Burlington Design Advisory Board

DESIGN ADVISORY BOARD Tuesday, July 12, 2022 3:00 PM

To: The Design Advisory Board
From: Mary O'Neil, AICP, Principal Planner
RE: ZP-22-398; 79 Pine Street
Date: July 12, 2022

To: The Design Advisory Board
From: Ryan Morrison, Associate Planner
RE: 86-88 North Winooski Street; ZP 22-386
Date: July 12, 2022

ROOF SCREEN VISIBLE (YELLOW)

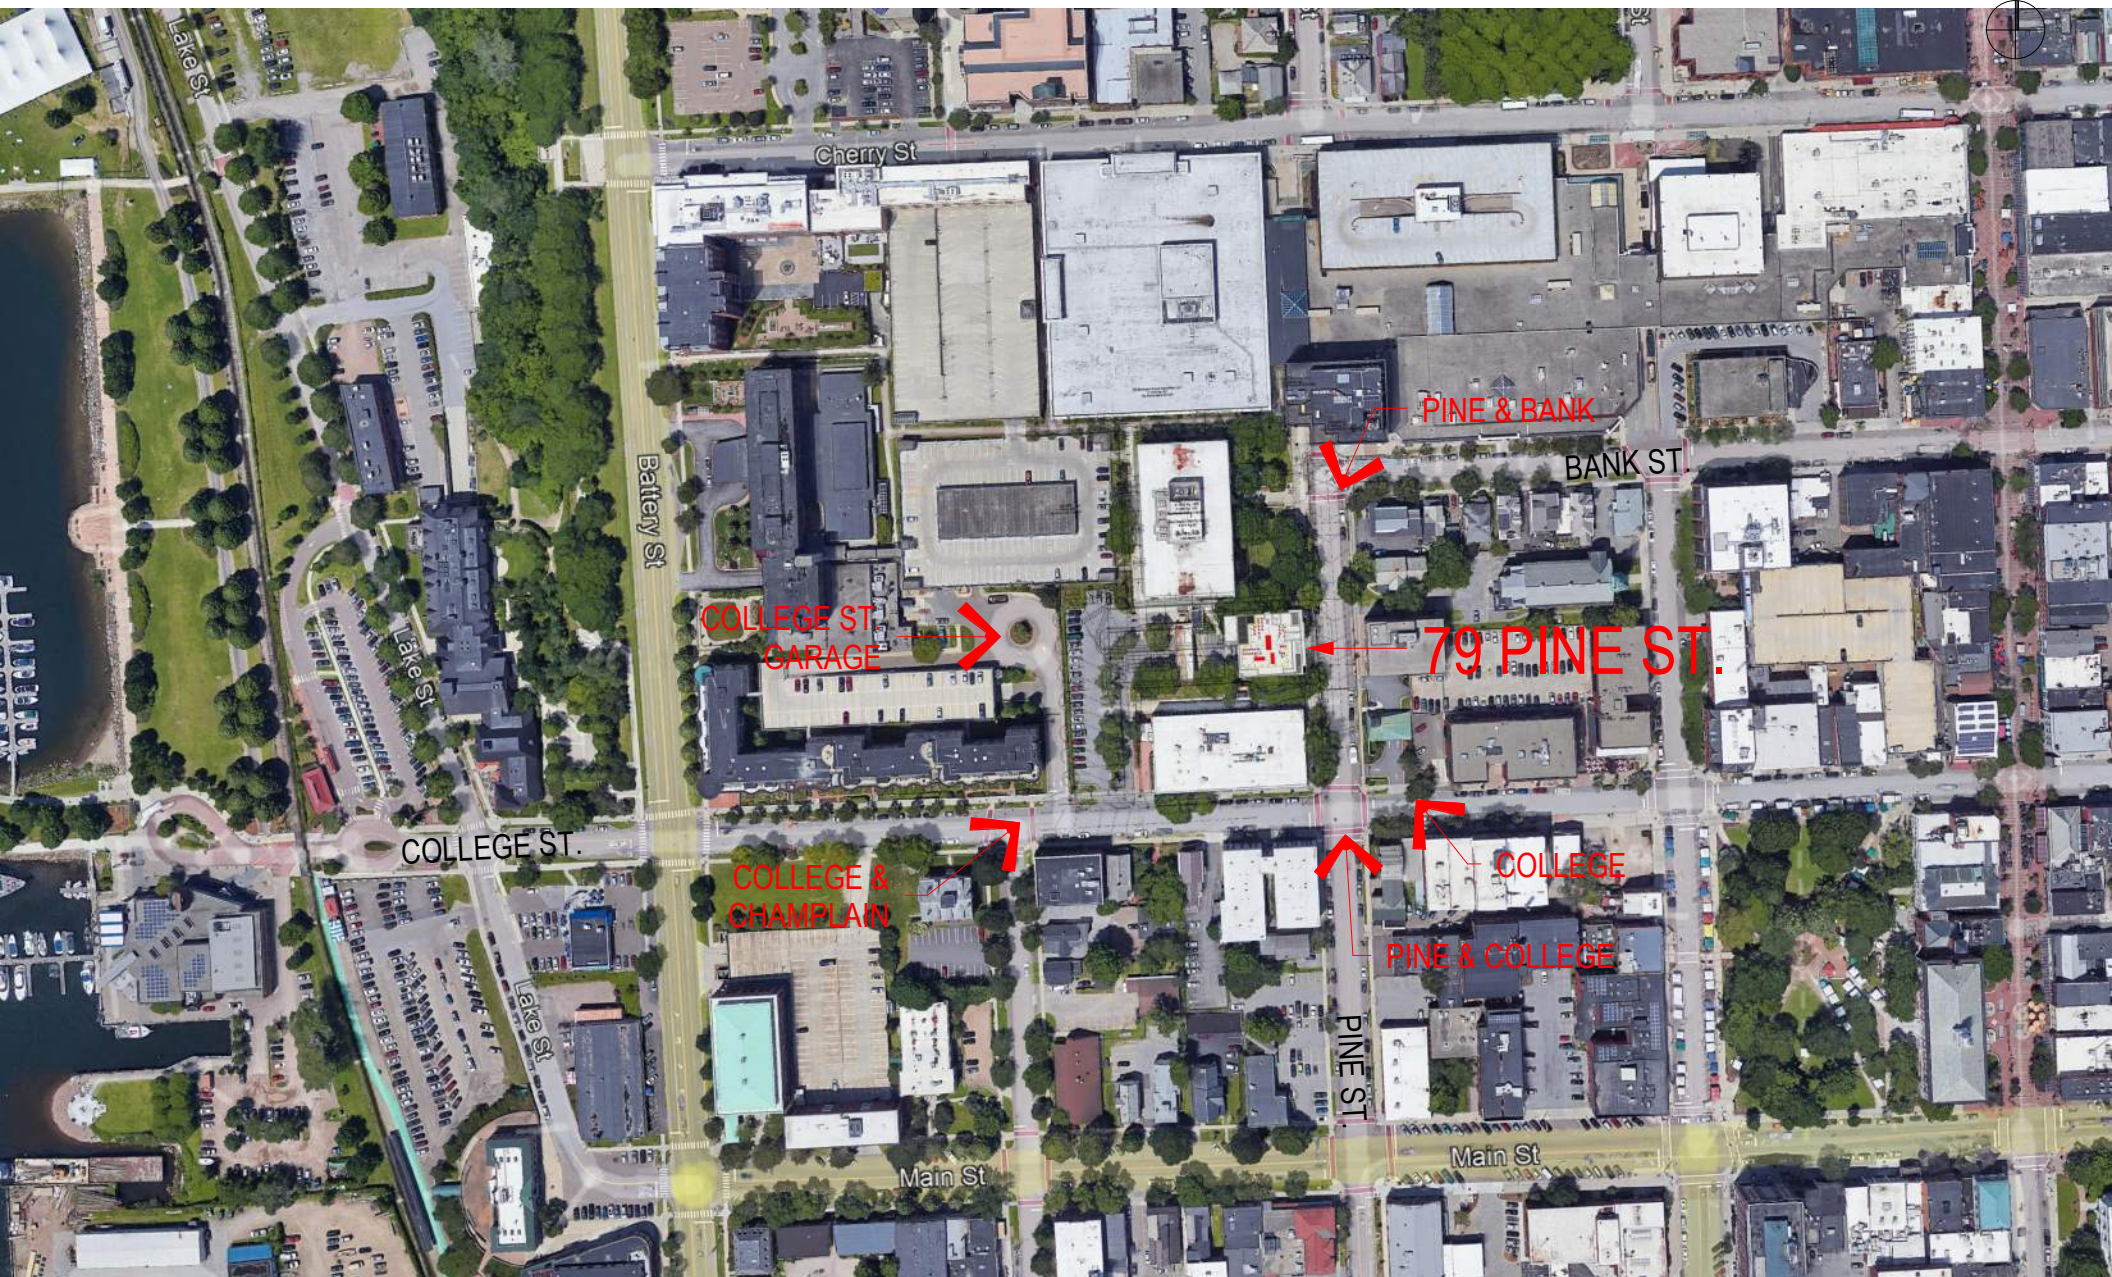
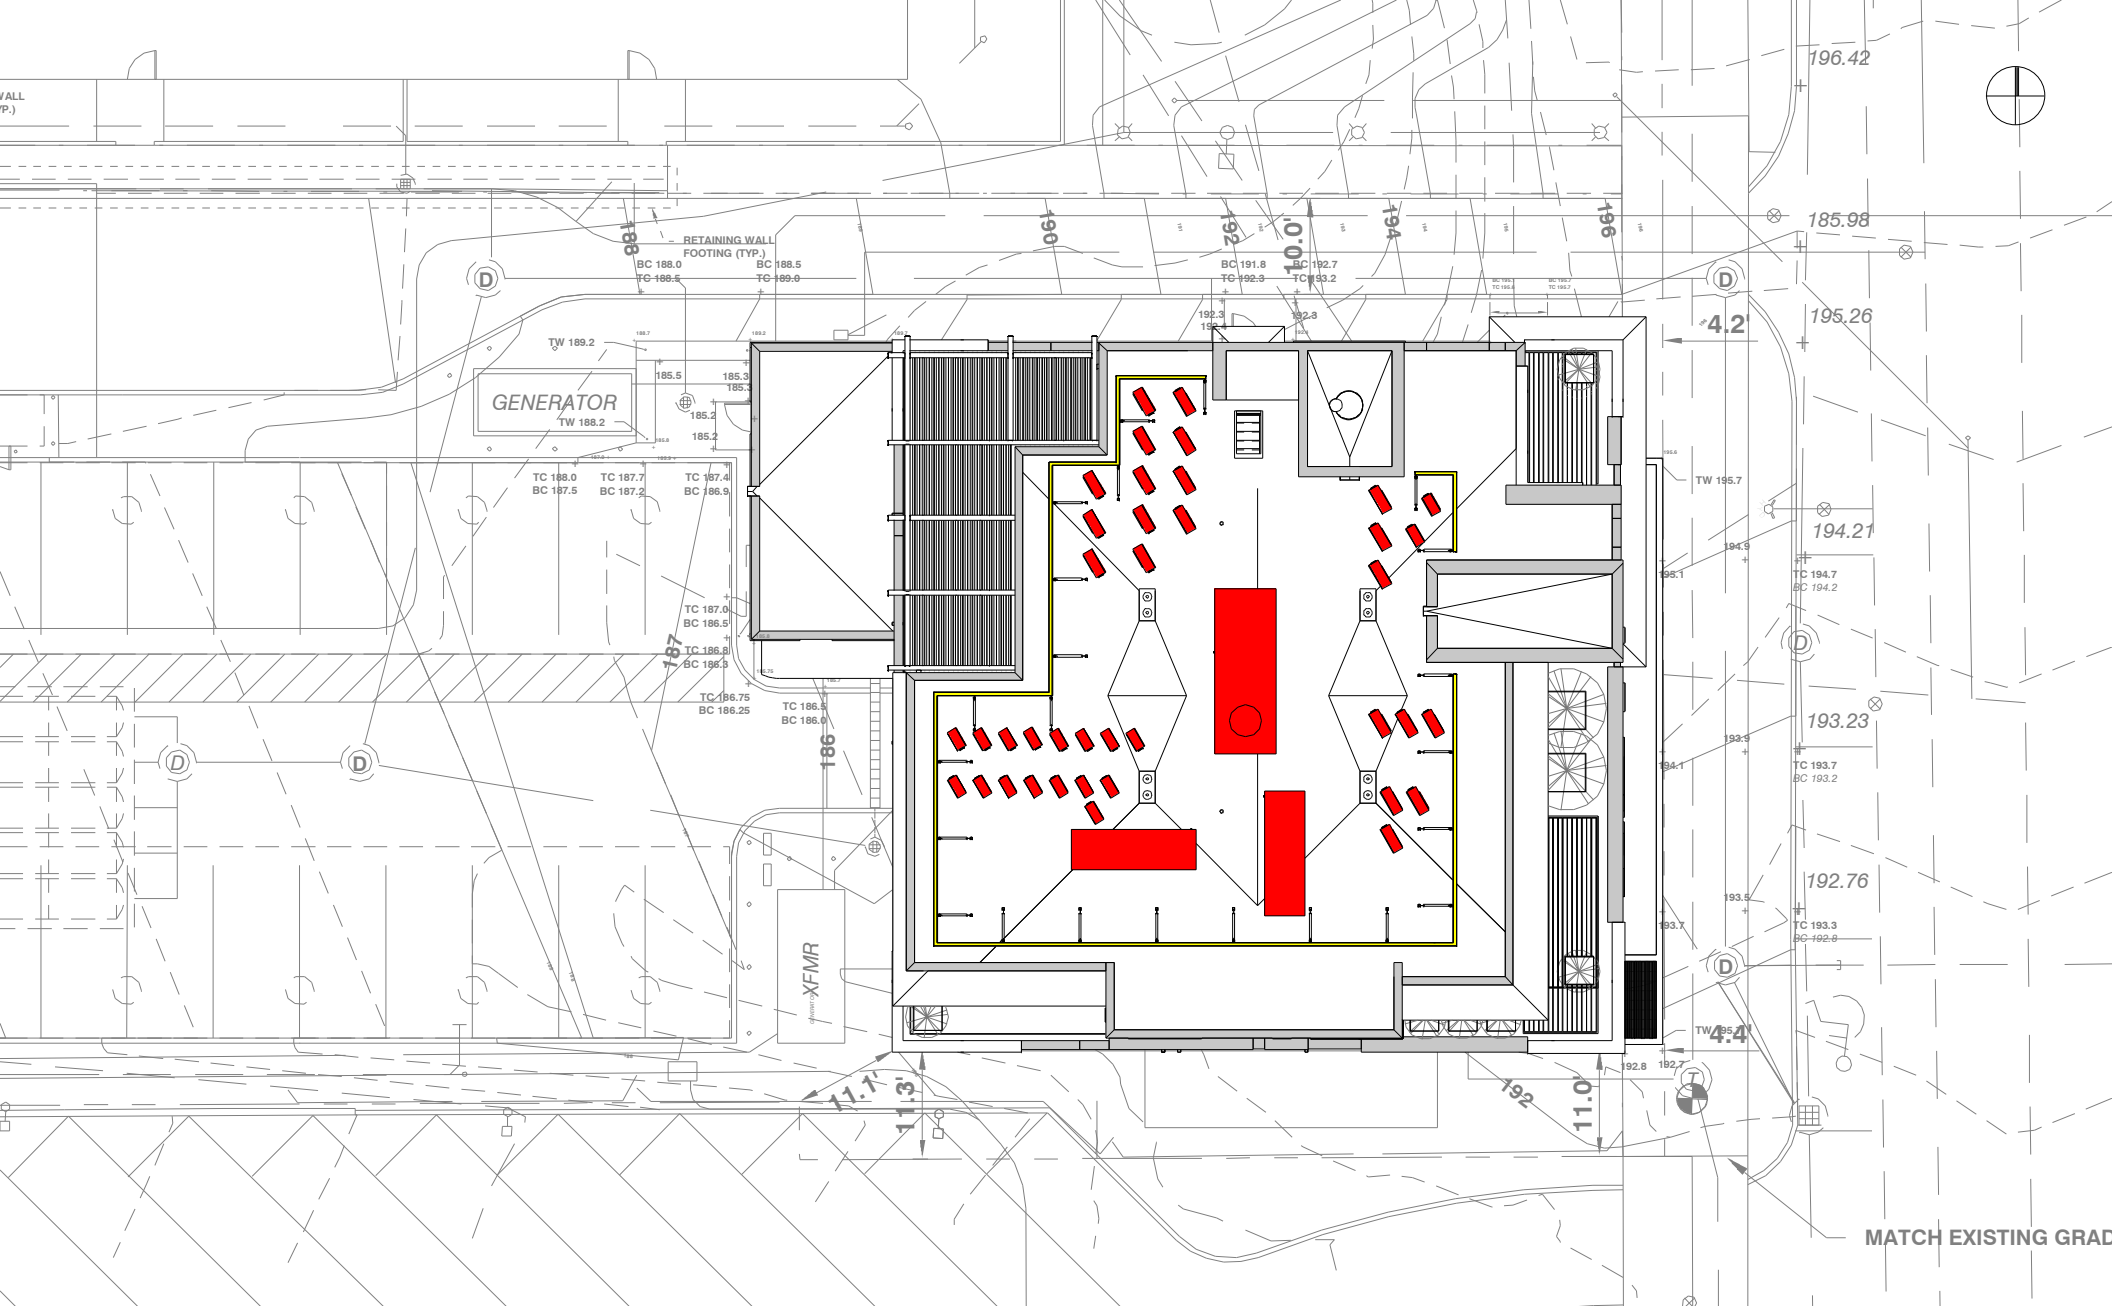
The applicant has demonstrated the increased visibility of non-design features (screening) that in fact create greater visual structure than the equipment that it is intended to shelter. The building has been designed with carefully placed rooftop equipment, the equipment will not be visible from the pedestrian way, and the proposed building itself screens the majority of the view. The applicant's request for Alternative Compliance is a reasoned one; particularly when consideration is given to its substantial cost (\$93,000), the roof punctures required for the installation of the screening, and its performance failure by introducing more rooftop clutter. Removal of the condition to screen will therefore provide greater compliance with the standard being relieved.

While rooftop mechanical screening was a Planning & Zoning requirement and a condition of the Development Review Board's spring 2021 decision #22, if we must add this mechanical screening, it will be visible on the Nest's roof from the street from every direction. Without screening, the Nest rooftop mechanicals won't be visible from the street view at all – totally hidden regardless of what direction you view the building from. Given this, we're asking for reconsideration of this condition as it doesn't seem to be in anyone's best interest.

1. Any conditions imposed by Zoning Permit 21-0927CA (Amanda database) or Zoning Permit 21-118 (Open Gov) not specifically altered by this decision.
2. Standard Permit Conditions 1-15.

Photo 6. Detail & Close-up of Collapsed Portion of Building

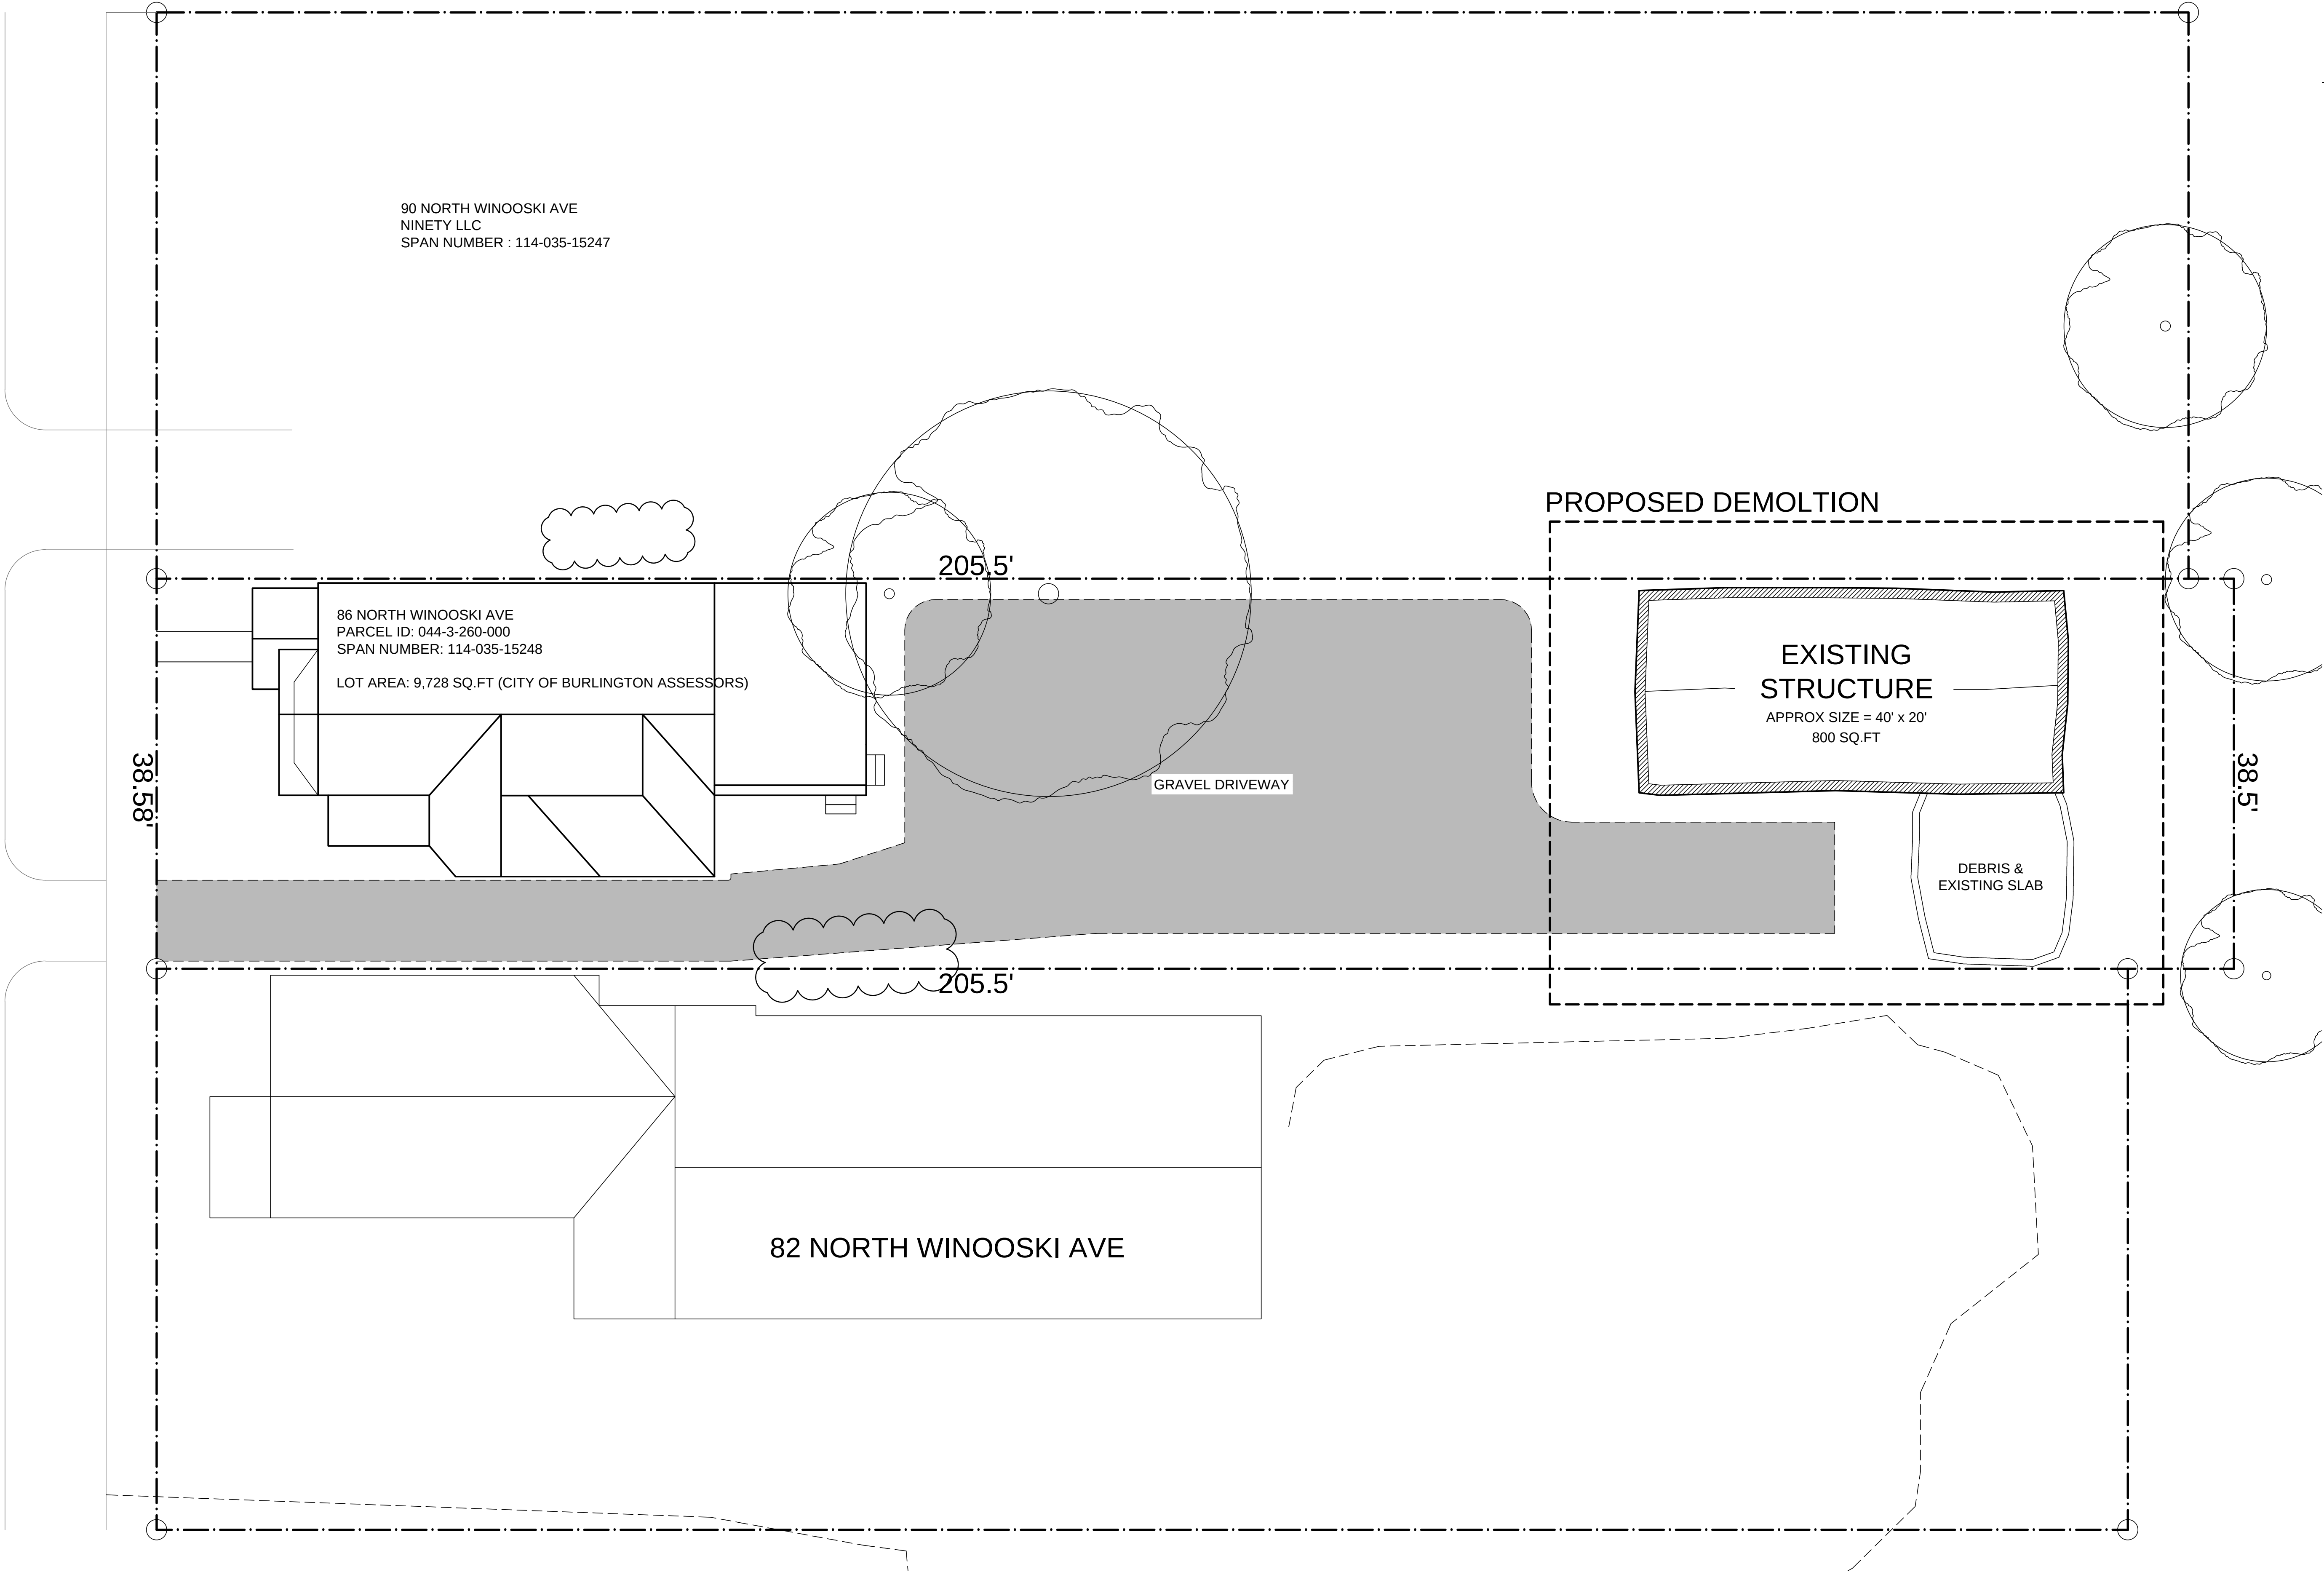
With regard to the remaining structure, the report identifies numerous structural issues. The structure appears to lean and is in severe disrepair. The southeast corner [where the garage portion attached] shows indication of damage from fire or collapse. Evidence of collapse along the south side exists, and there is indication of fire damage on the roof, roof beams, walls and floor. Roof structural members are undersized and insufficient, and the architect notes that rehabilitation of the structural members will not adequately provide safe and sufficient support. Loose rubble, mixed masonry and stone have been placed for foundation. The walls are bowing due to poor connection to a proper foundation and inadequate structure. The report goes on to identify other insufficiencies with the remaining structure, and that it has limited salvage value.

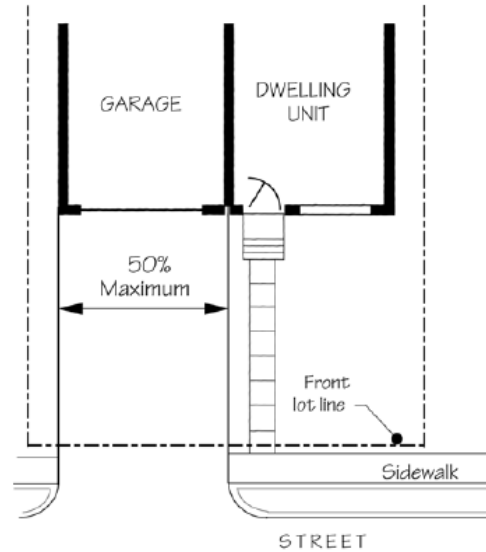
The street-facing wall of the garage constitutes more than 50% of the width of the street-facing façade and thus living space is required above. But what constitutes ‘above’ here? The principal house structure will situate further back slopeside, whereas the garage will locate closer to the street edge. Additionally, the upper floors are only connected to the garage via an elevator shaft, with an approximate 22 ft open-air gap between the two. Staff is of the position that living space in this configuration, above the garage that exceeds 50% of the width of the street-facing façade, does not constitute living space above the garage, which is required here. The disconnect between the garage and living space is too great to consider this requirement met.

The garage doors do not appear to exceed 10 ft in width.
